RFB947600-01 ADDENDUM #01

DATE: November 4, 2025
PROJECT: 9476.00 HHS STS New Garage Building
BID DUE DATE: November 13, 2025 @ 2:00 pm
TO: All Contract Document Holders of Record.

1 MECHANICAL PLAN
SCALE: 1/4" = 1'-0"

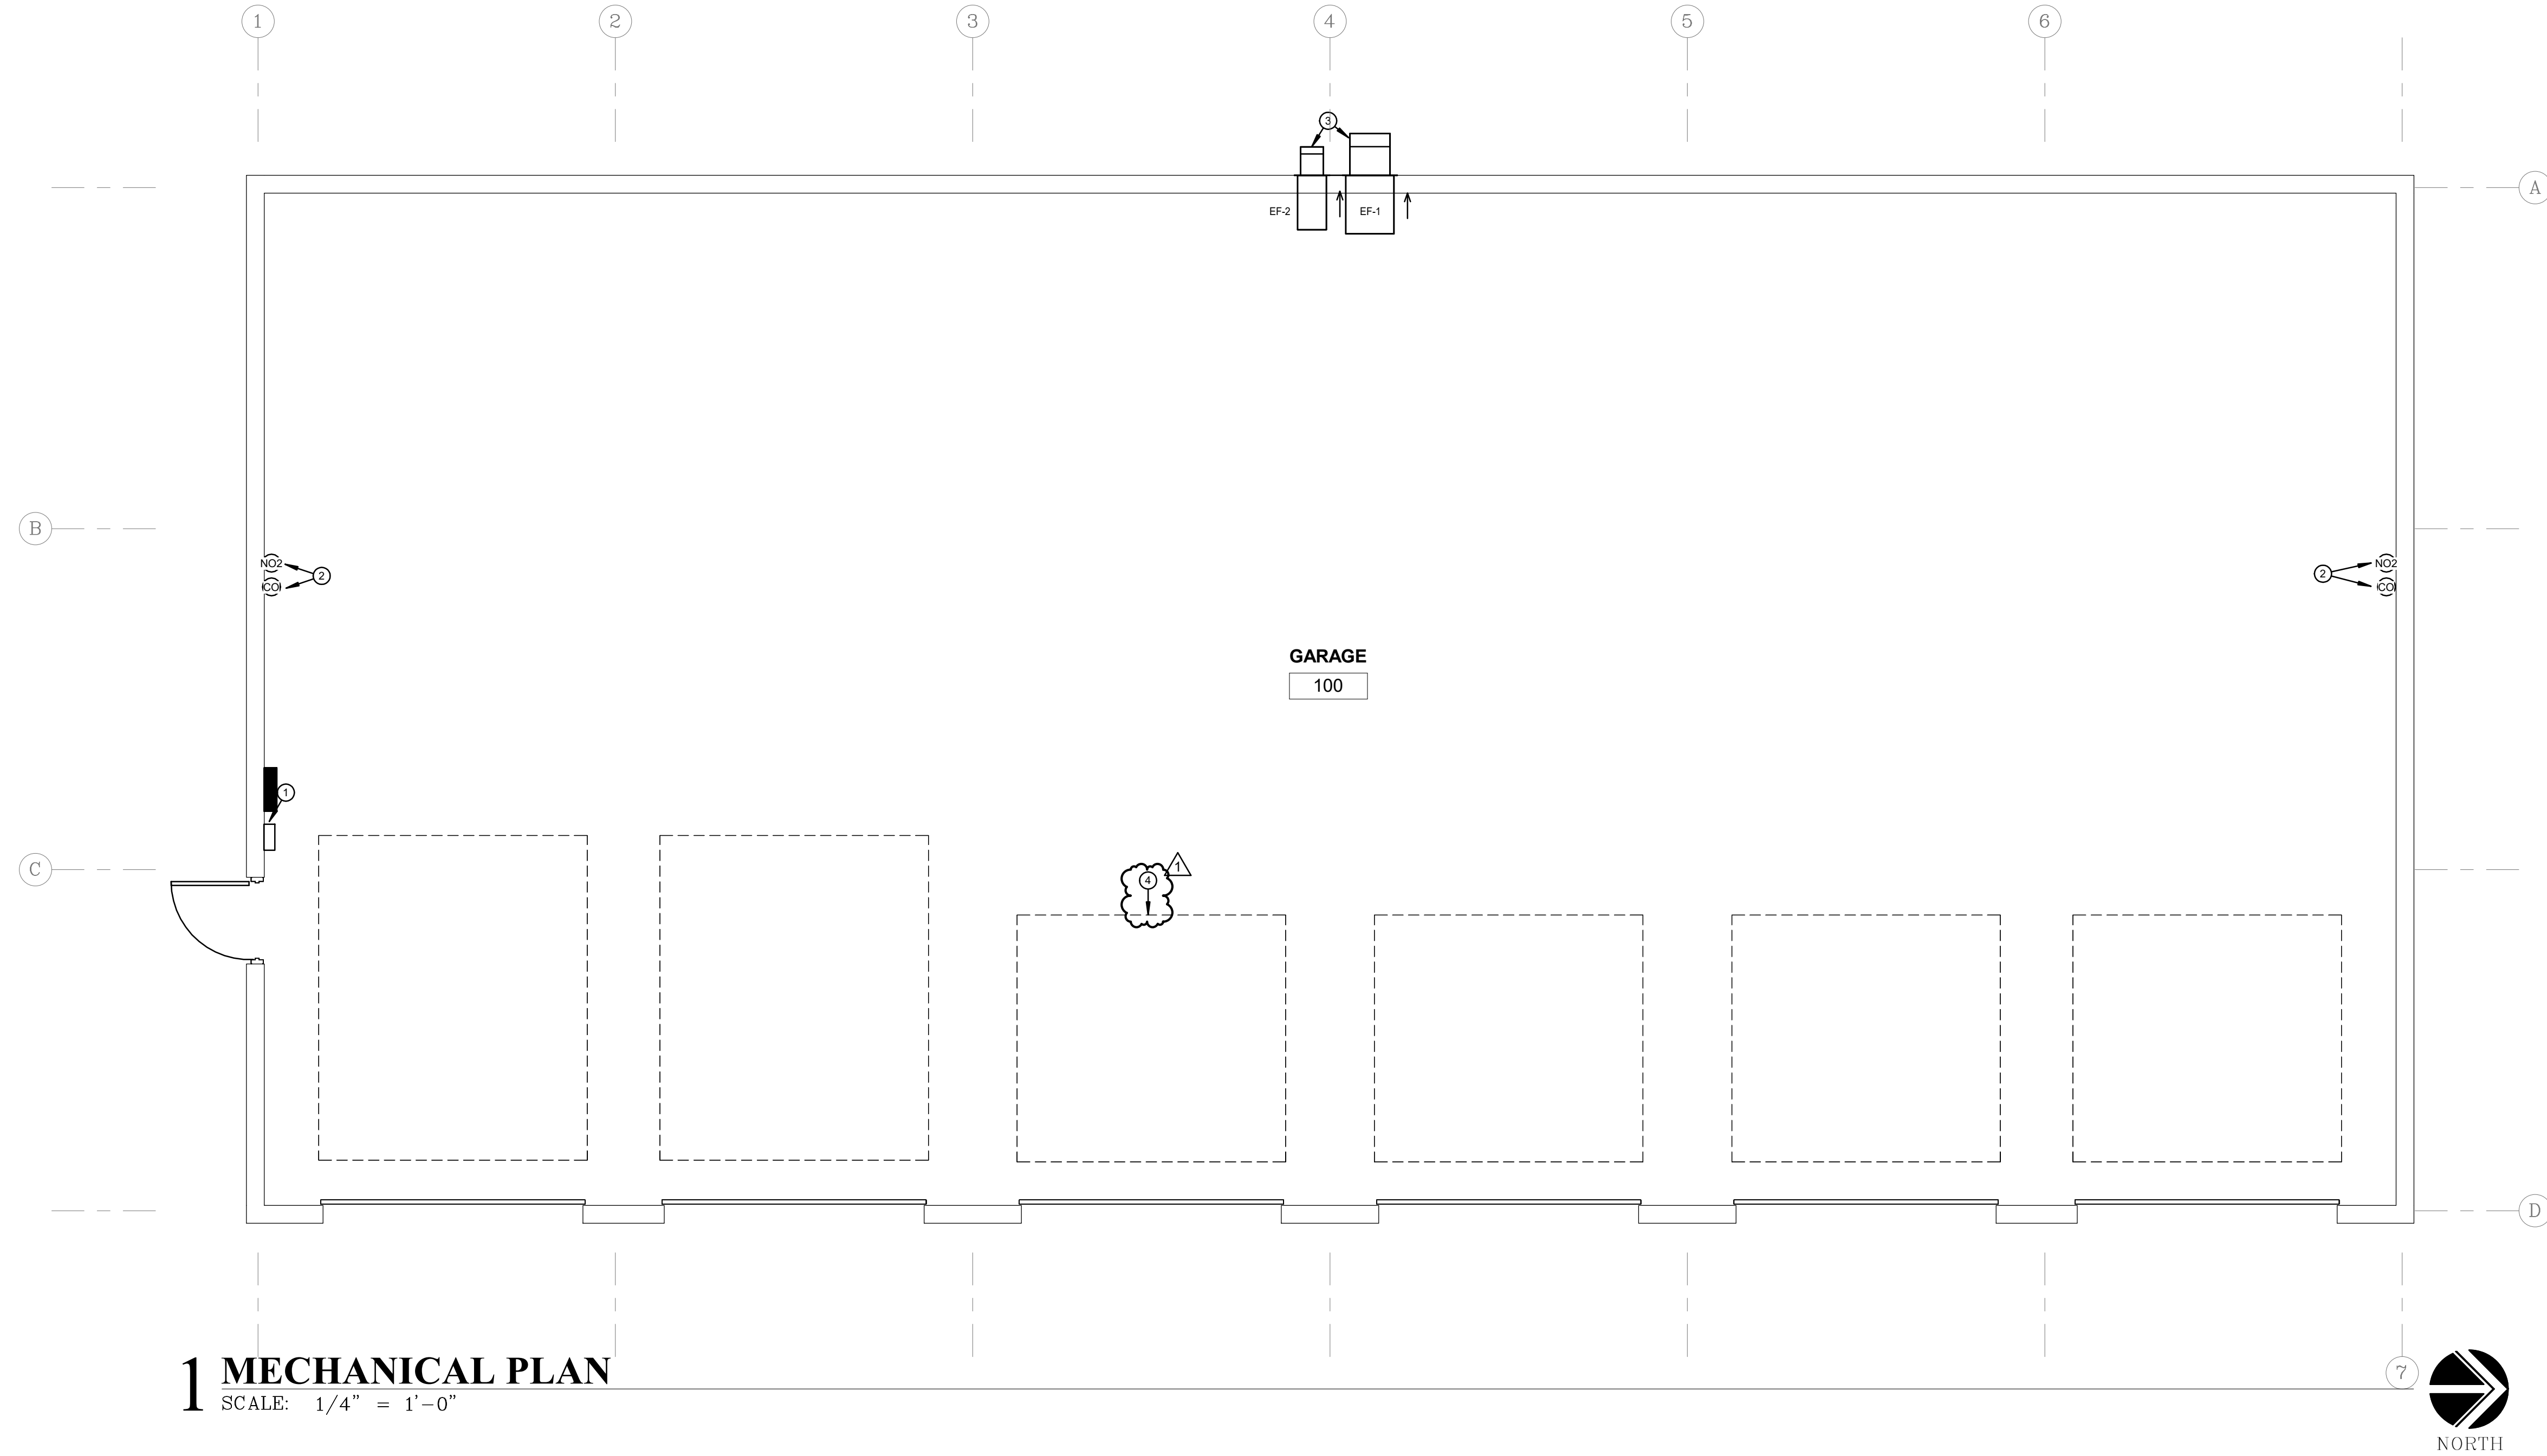
Q4. On page M1.1, keynote 4 points to the middle two garage doors. This note states each garage door to be provided with a dry contact integrated into toxic gas detection, etc. Is this meant just for these two middle doors, or will this be for all doors?

- 1. Sheet M1.1 Mechanical Plan
 - A. Revised sheet note to have a single garage door open during a toxic gas detection system alarm.

A4. The sensor(s) are not needed at all doors. And, as an additional cost savings measure, only one (1) door will require this. See M1.1 updated below.

- 1 TOXIC GAS DETECTION SYSTEM CONTROLLER INTEGRATED WITH TOXIC GAS EXHAUST FAN (EF-1).
- 2 CARBON MONOXIDE (CO) AND NITROGEN DIOXIDE (NO2) DETECTORS FOR EF-1 AND EF-2 TOXIC GAS SYSTEM. INSTALL CARBON MONOXIDE (CO) DETECTOR AND NITROGEN DIOXIDE (NO2) DETECTOR ABOVE THE FLOOR FOR DETECTION IN BREATHABLE AREA. SEE MANUFACTURER'S RECOMMENDATIONS FOR ALL OTHER.
- 3 MOUNT FANS AT 9'-0" A.F.F. AND SPACE FAN OUTLETS AT 6" APART AS REQUIRED TO ALLOW FOR FRAMING.
- 4 THE GARAGE DOOR INDICATED SHALL BE PROVIDED WITH A DRY CONTACT THAT SHALL BE INTEGRATED INTO THE TOXIC GAS DETECTION SYSTEM. WHEN THE GAS DETECTION SYSTEM ALARMS, EXHAUST FAN EF-1 SHALL ENERGIZE AND THE GARAGE DOOR SHALL OPEN.
